Dell™ PowerEdge™
2900 Systems
Information Update

This document provides updated information for your system on the following topics:

Figure 1-1. Internal USB Connector Location

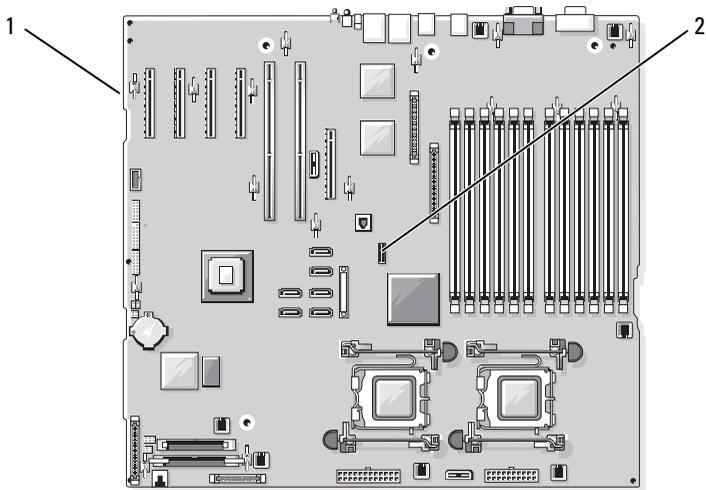
The PowerEdge 2900 III system provides an internal USB connector located on the system board for use with a USB flash memory key (see Figure 1-1). The USB memory key can be used as a boot device, security key, or mass storage device. To use the internal USB connector, the **Internal USB Port** option must be enabled in the **Integrated Devices** screen of the System Setup program. See "Integrated Devices Screen" on page 20.

Figure 1-2. Installing an Internal USB Key

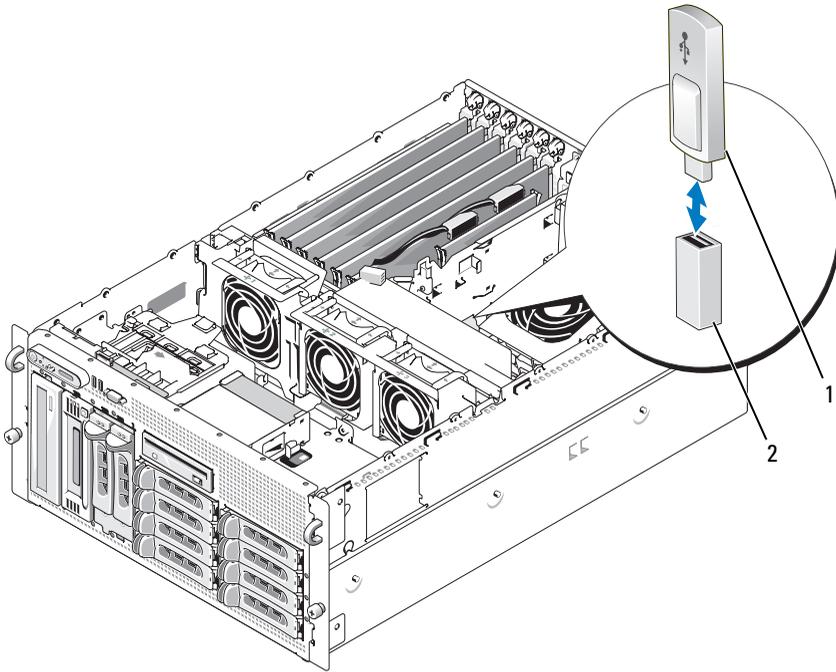
- 1 Turn off the system, including any attached peripherals, and disconnect the system from its electrical outlet.
- 2 Open the system. See “Opening the System” in the *Hardware Owner’s Manual*.
- 3 Locate the USB connector on the system board, and insert the USB memory key into the USB connector. See Figure 1-2.

Figure 1-3. Removing the System Board

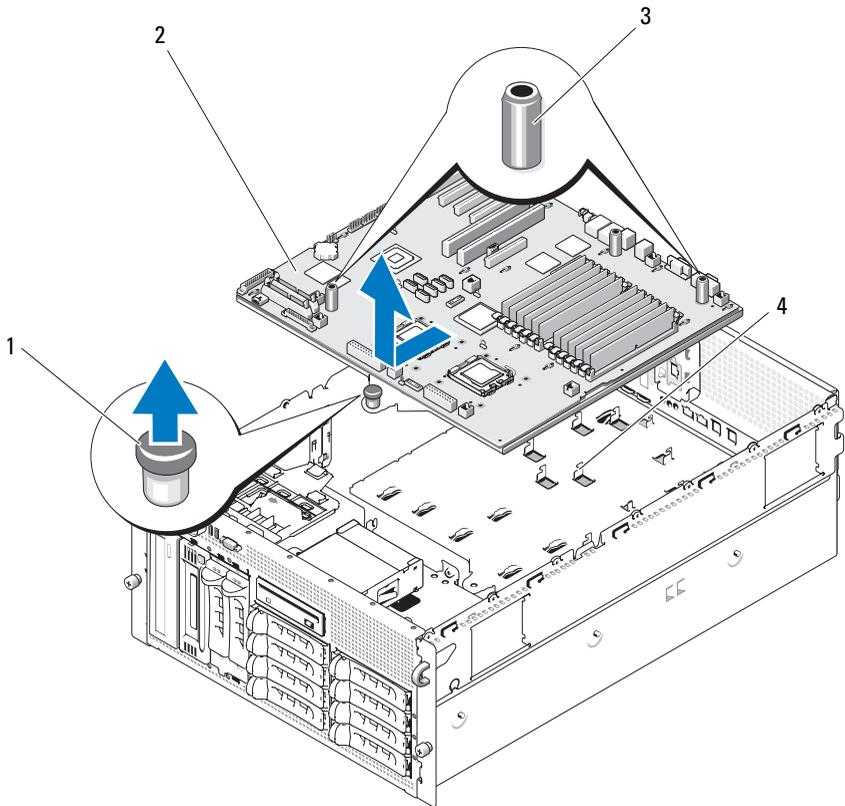
The procedure given in the *Hardware Owner's Manual* to replace the system board has been updated. When removing or installing the system board, lift or hold the system board by the retention pin and the system board handles (see Figure 1-3).

**NOTICE:** To avoid damage to your system board, do not lift the system board by the memory module retention brackets or by any component on the system board except for the system board handles.
